Stockholm's Skarpnack Field

2009 World Cup Venue Evaluation

IBAF Field Evaluation

Equipment Improvements

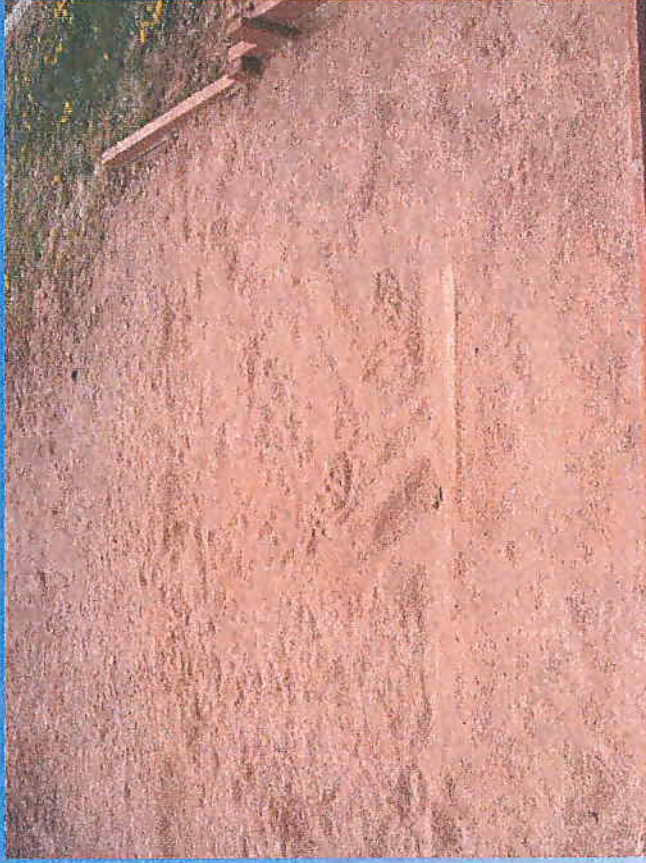
Replacement of L screen to 8x8 unit. Three additional screens at 8x8 w/new nets
